Plan Commission

Monday, December 21, 2020

SUBJECT: Consideration and possible action on a request for a site plan to add 71,255 SF to an existing building at 1800-1862 Commerce DR (Parcels ED-344-101-1, ED-344-101-5).

Staff recommends APPROVAL of the site plan request for a new 71,255 SF industrial building addition at 1800-1862 Commerce DR, subject to compliance with the conditions listed in the 'Staff Comments' section of this report.

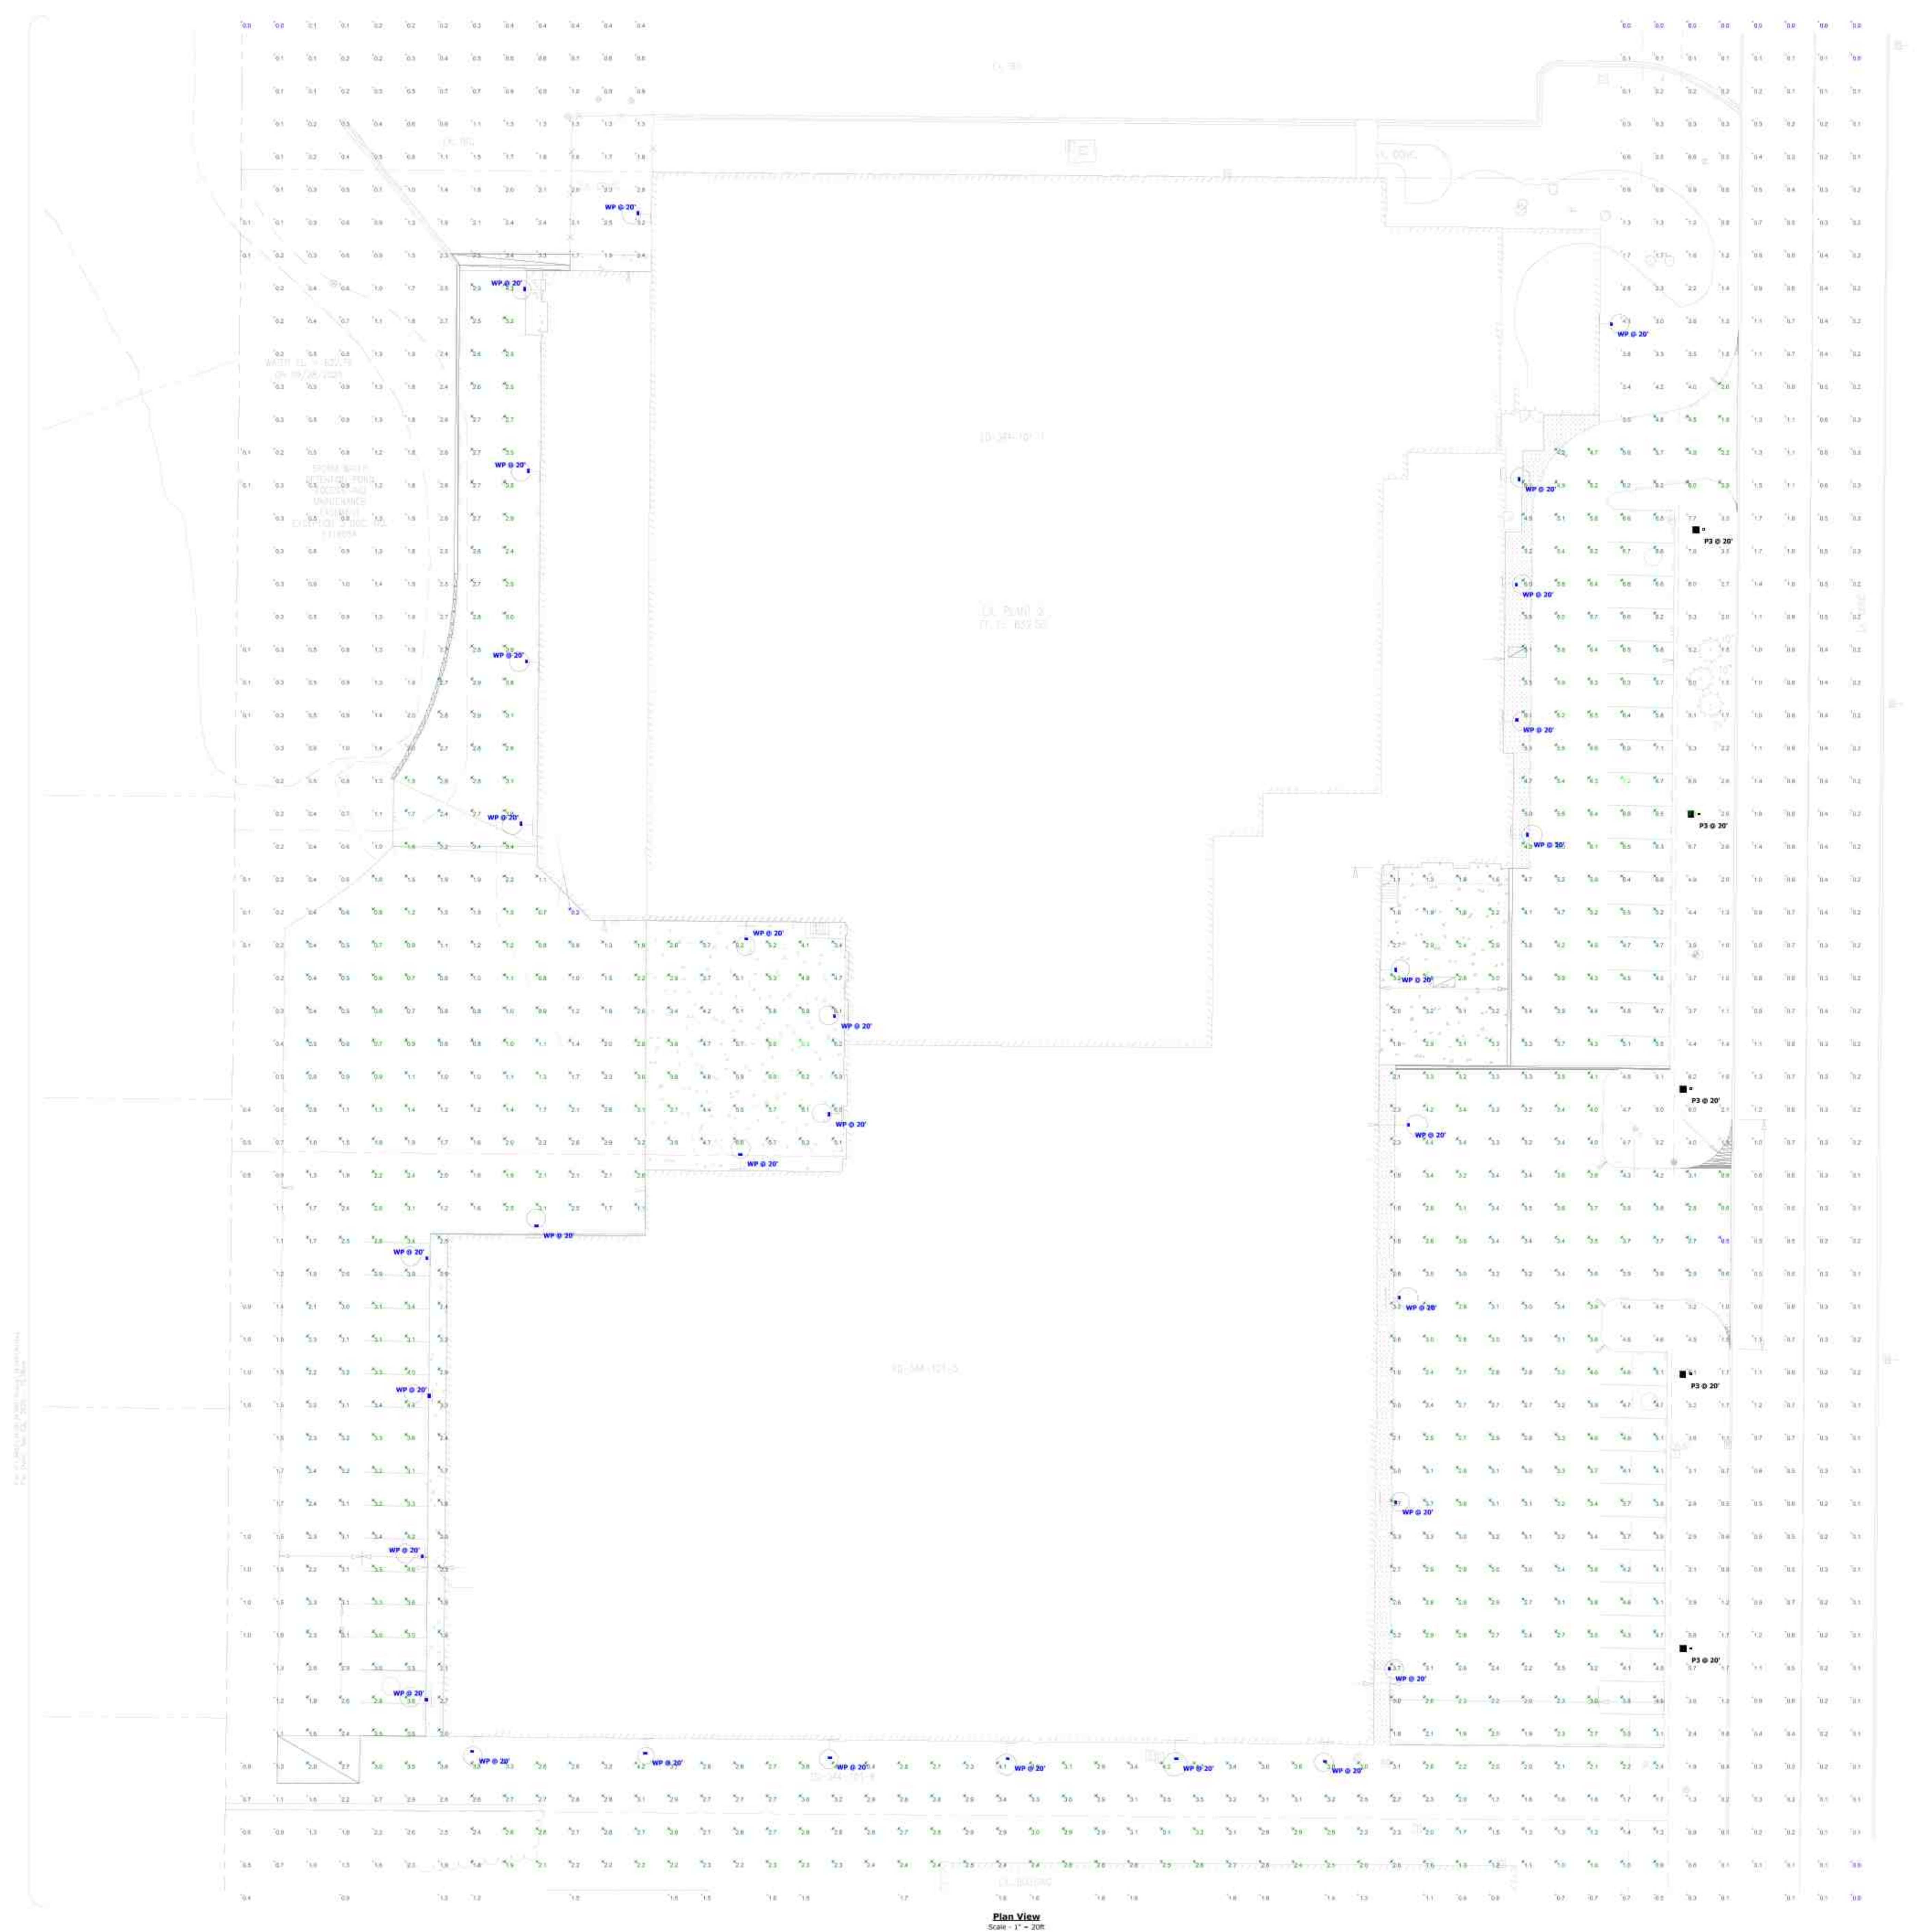
The landscaping plan has been modified for this project. The most significant feature to consider is the screening for the transitional yards at the rear of the proposed addition. Adequate landscaping and screening is required. The developer proposed a row of trees and plantings to screen the area.
